DRAFT

<u>Page</u>
6 SUITABILITY OF THE SITE FOR SITE CHARACTERIZATION AND FOR DEVELOPMENT AS A REPOSITORY	6-1
6.1 Guidelines that do and do not require site characterization	6-1

Figure 6-1. United States census populations for 1980 of cities within an 80-kilometer (50-mile) radius of the Hanford Meteorological Station.

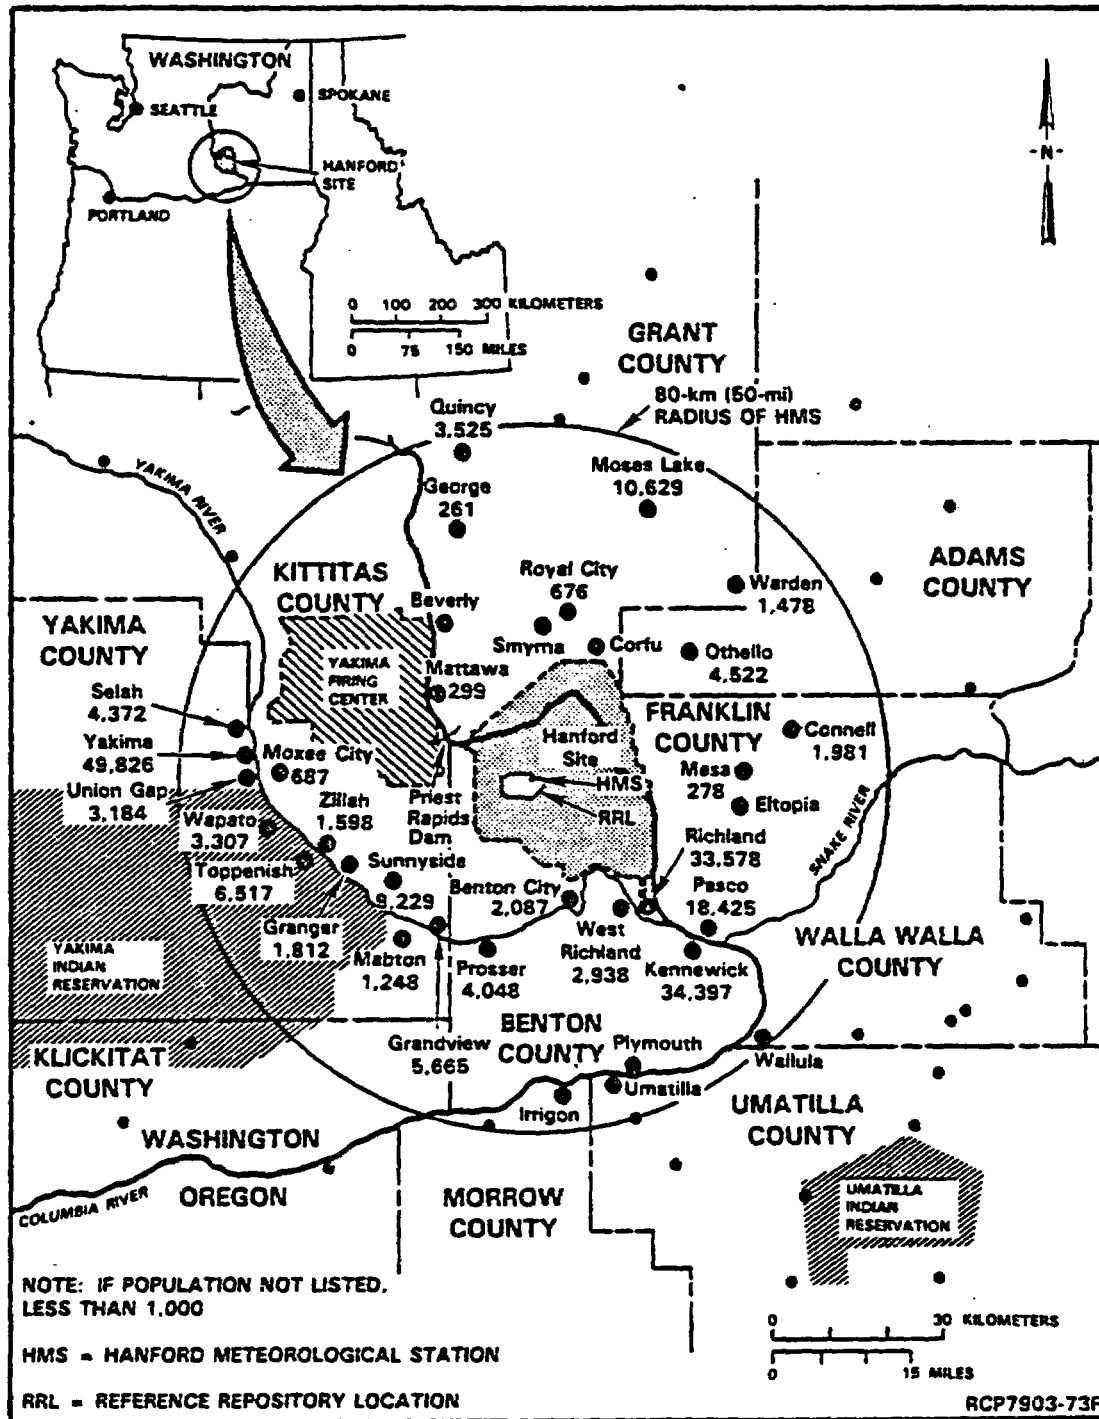
add Midway? Pagesy deleted at several drafts (gd)

Figure 6-2. Location of existing and planned commercial reactors and storage facilities with light water reactor commercial spent fuel (taken from DOE, 1983c, p. 18).

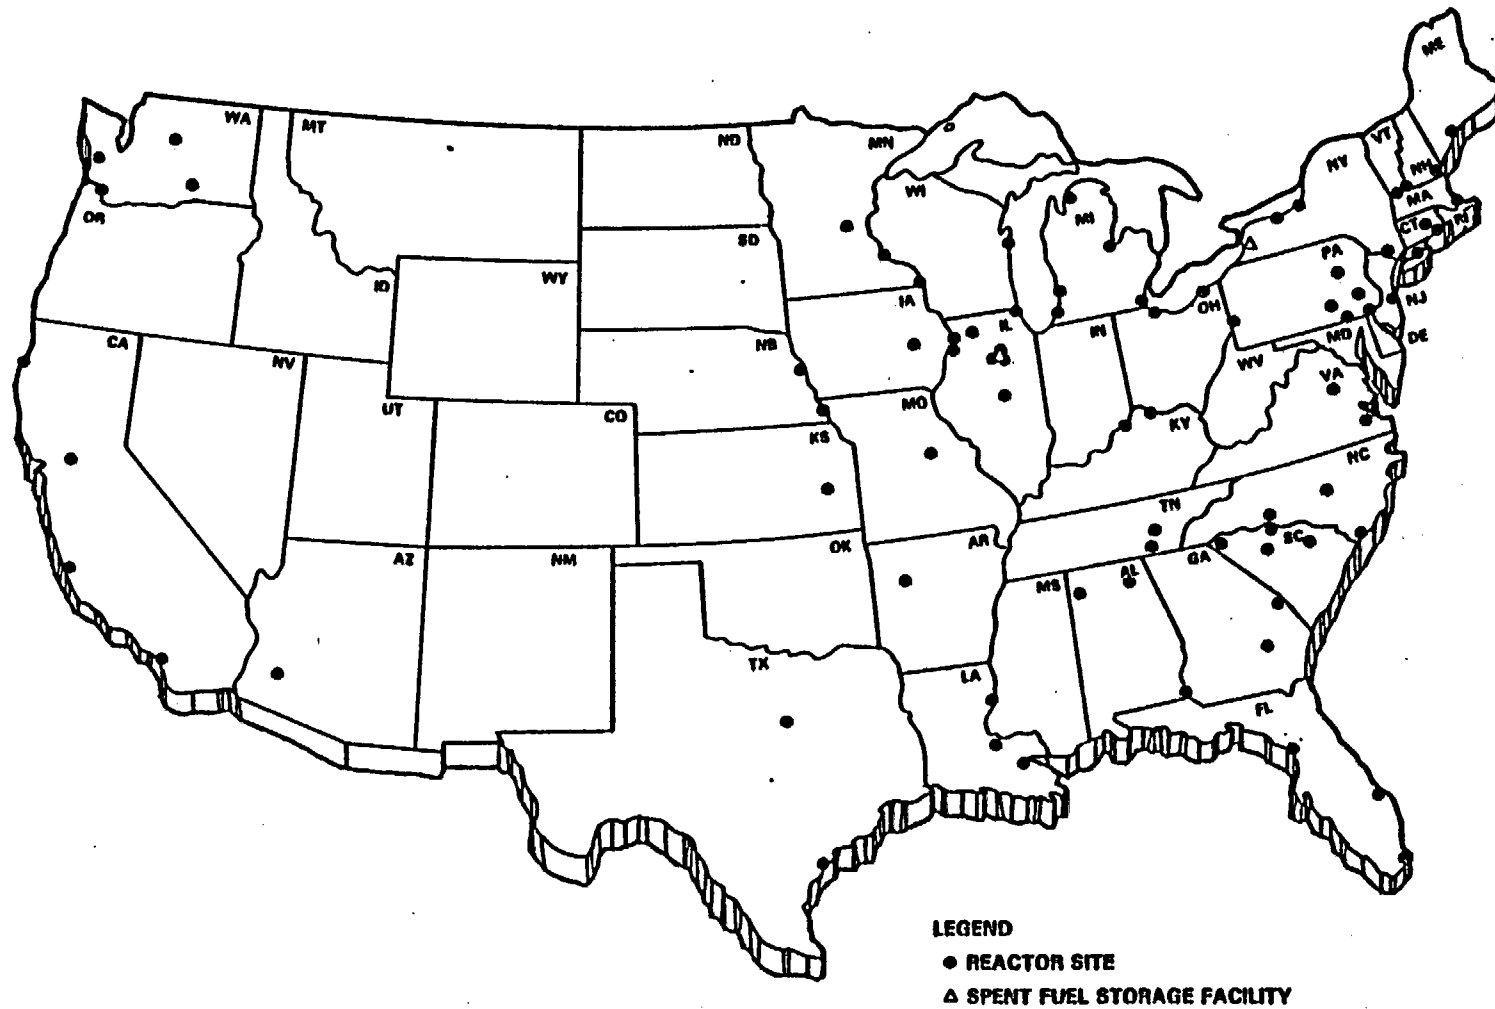
*on the Hanford
Site just
north of
Richland, Wa.*

FIGURE 6-4. Estimated Range of permeabilities (K_z) in the disturbed zone for the direction parallel to the ^{rock} axis of the opening.

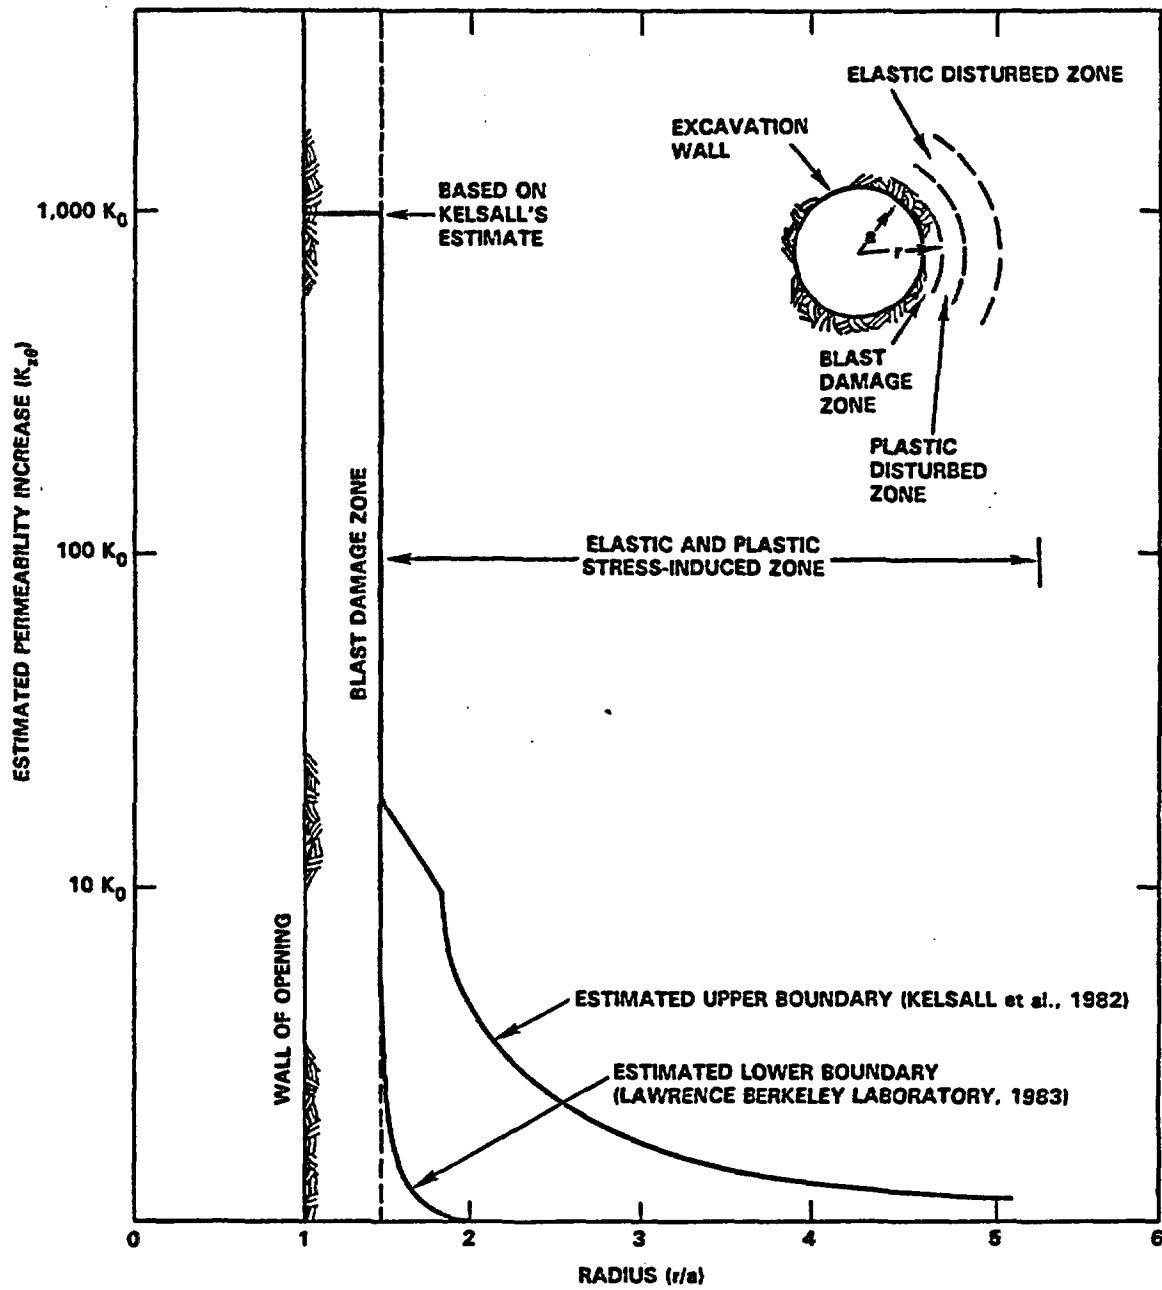
Based on the performance assessment studies presented in Section 6.4.2, ~~it is apparent that the 30-meter (98-foot) dense interior thickness criteria is~~ more than adequate to ensure isolation. Results of these performance assessment studies indicate that there is a very high probability that U.S. Department of Energy guidelines, U.S. Nuclear Regulatory Commission criteria, and U.S. Environmental Protection Agency standards will be met without taking credit for any of the natural ~~barrier~~ *isolation* characteristics of the dense interior. The criteria in 10 CFR 60.113 (NRC, 1982a) requires ~~that~~ pre-waste ground-water travel time along the *X* fastest path of likely radionuclide travel from the disturbed zone to the accessible environment shall be at least 1,000 years. Preliminary performance assessment studies indicate that the range of expected median ground-water travel times could be on the order of 17,000 to 86,000 years. These ground-water travel times were computed from a starting point located in the flow top overlying the emplacement horizon at the downstream edge of the repository to the accessible environment, which was taken to be at 10 kilometers (6.2 miles) ~~from the starting~~ *flow path* point. This is a very conservative ~~study~~ and does not include, or take credit for, the natural isolation benefits of the dense interior. Therefore, ground-water travel times from the emplacement horizon can be expected to be much greater *since groundwater flow must pass through the relatively less permeable dense interior*.

Figure 6-¹⁵~~16~~. ~~Importance of radionuclides relative to estimated carbon-14 releases from the waste package~~

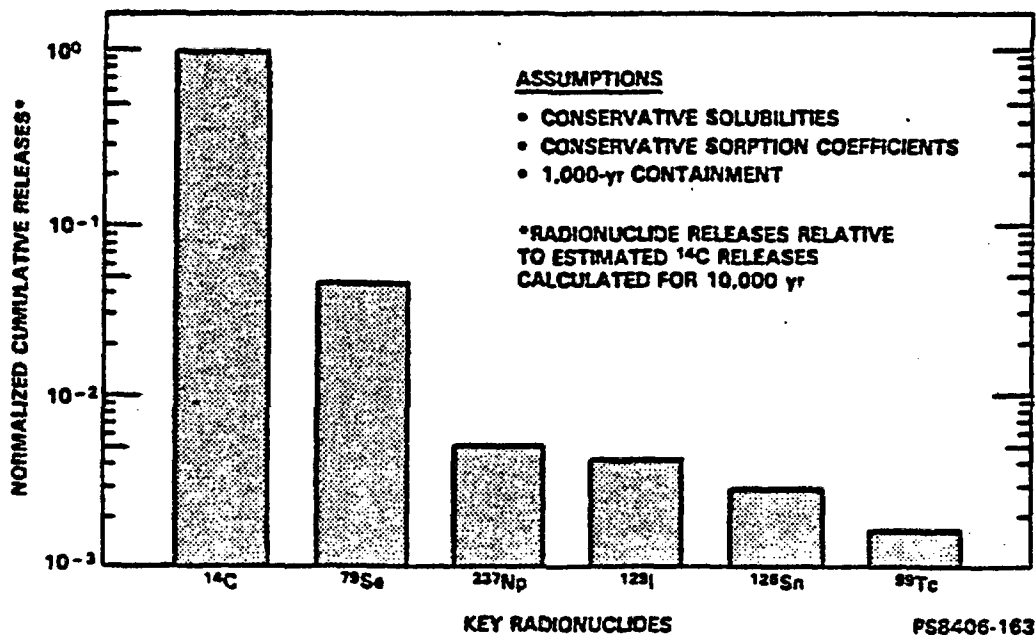
Comparative importance of radionuclides to assessment of isolation performance of the waste package subsystem.
